SUBJECT: PLANS AND PROPOSAL ADDENDUMS
PROJECT: STP 2023 (675)MM CONTROL: 1433-02-044
COUNTY: COMAL
LETTING: 05/04/2023
REFERENCE NO: 0419

PROPOSAL ADDENDUMS

DESCRIPTION OF ABOVE CHANGES
(INCLUDING PLANS SHEET CHANGES)

**PLAN SUBJECT TO CHANGE
AS UTILITIES ARE INSTALLED**

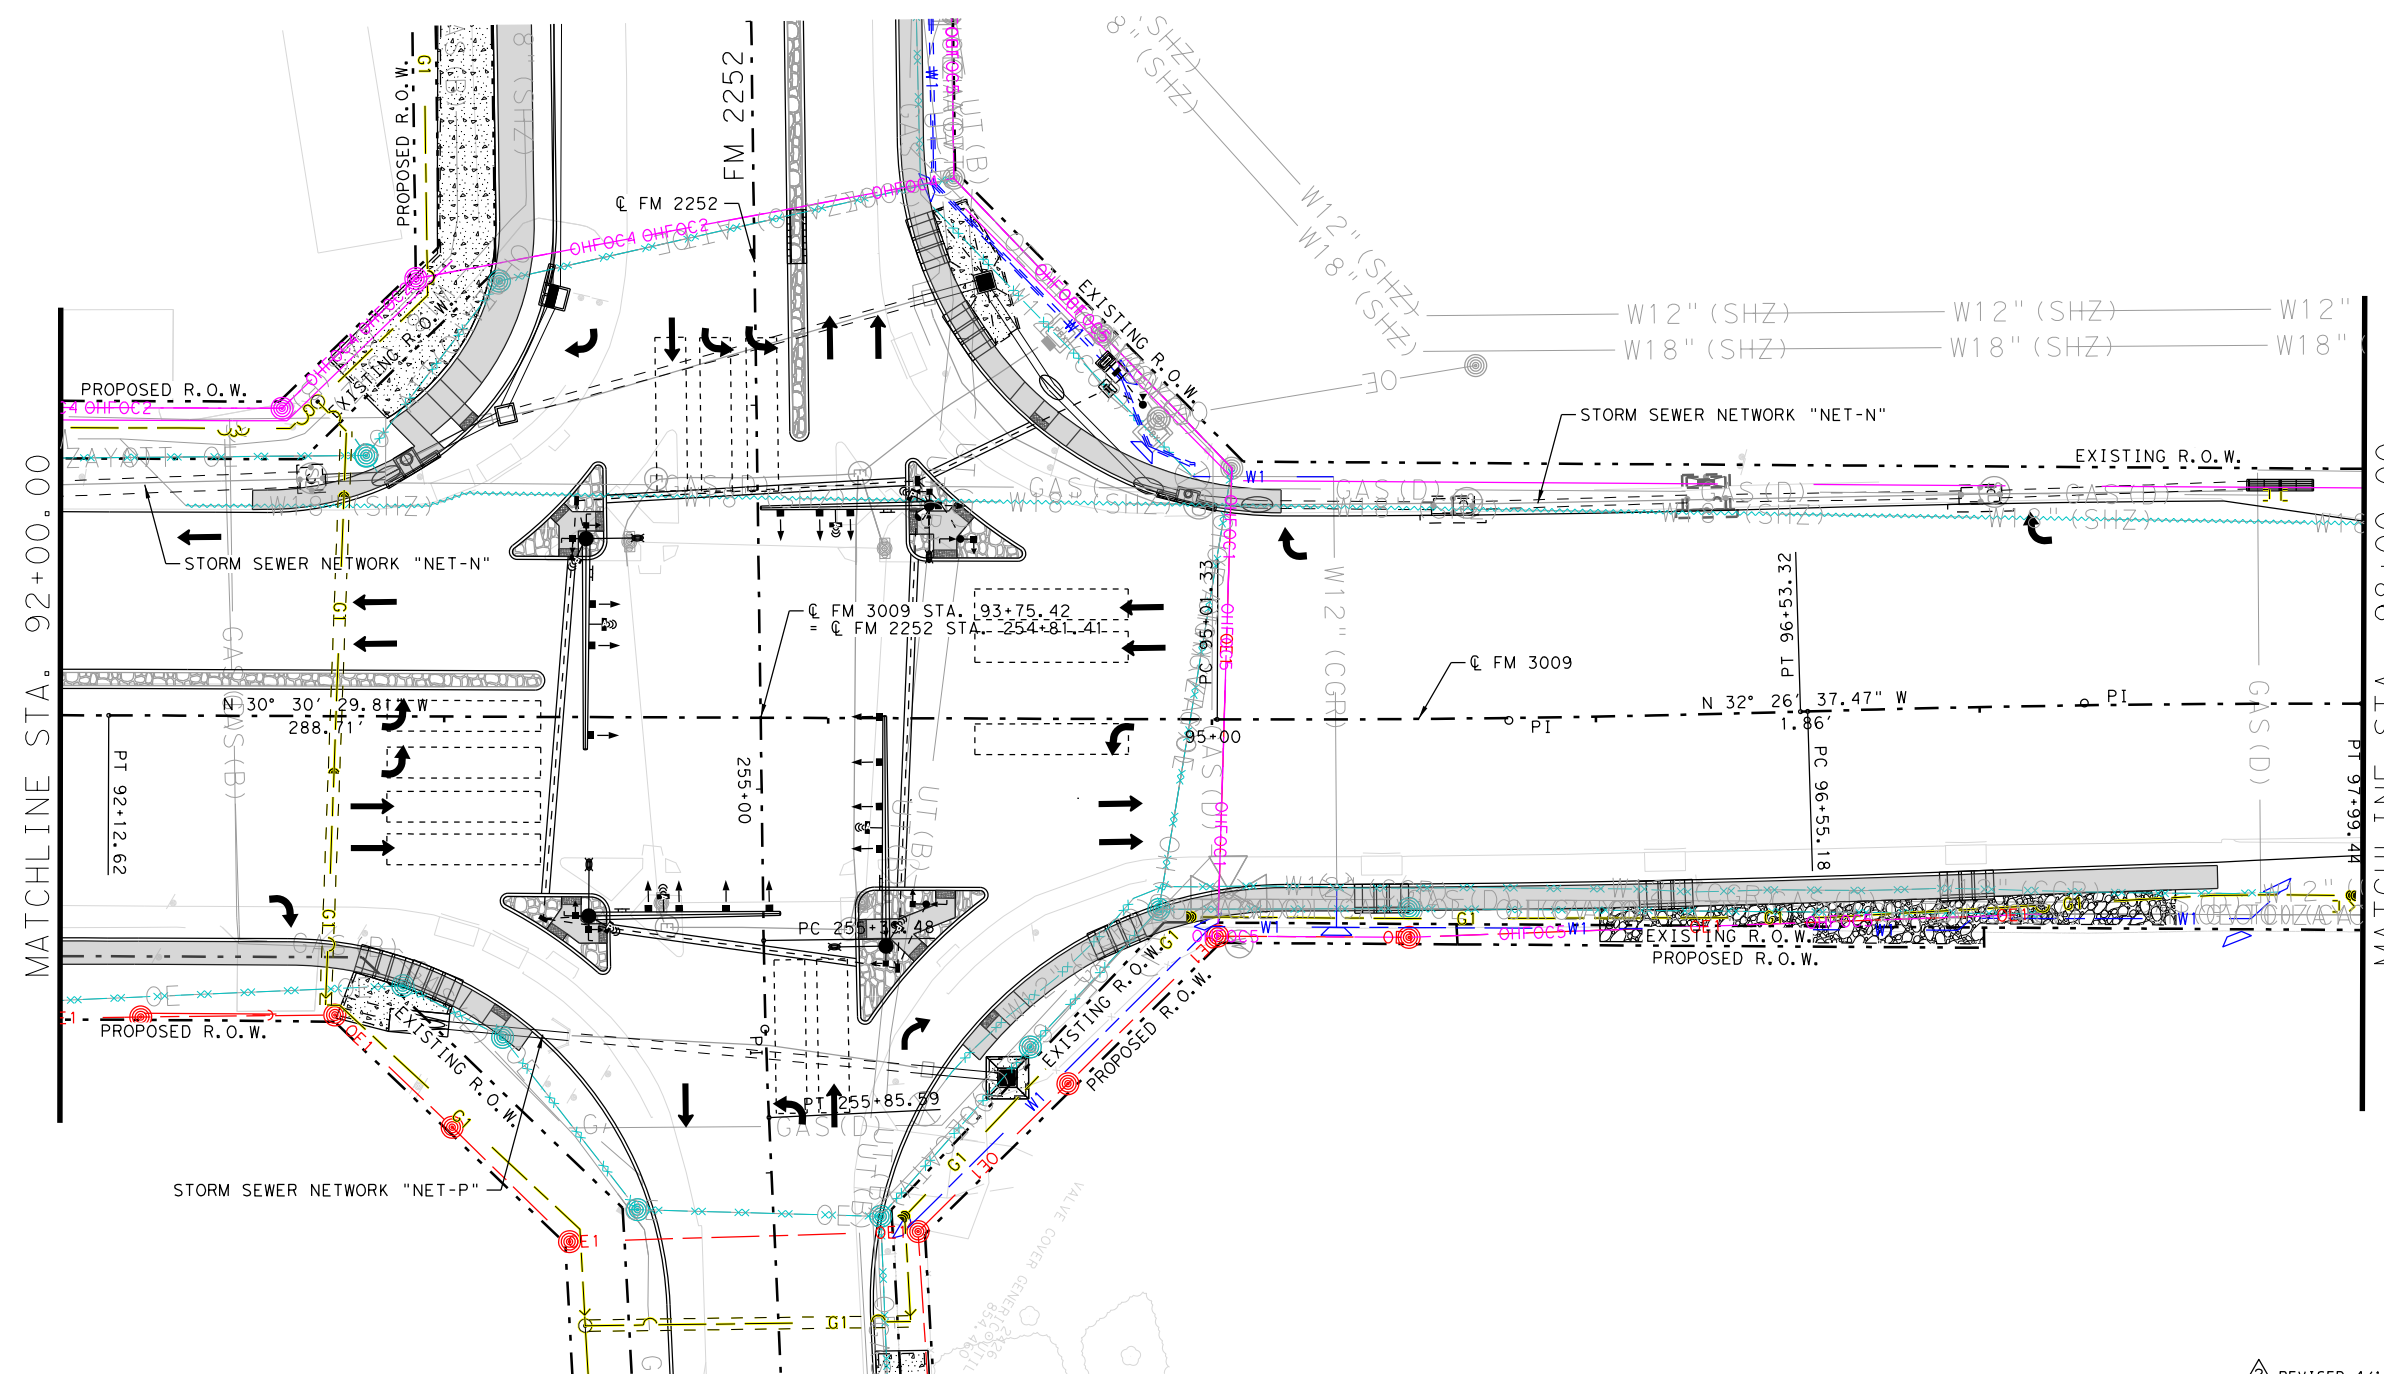
SHEETS 1330-1365: UPDATED UTILITY PLANS SHEETS LAYOUTS WITH CURRENT GAS
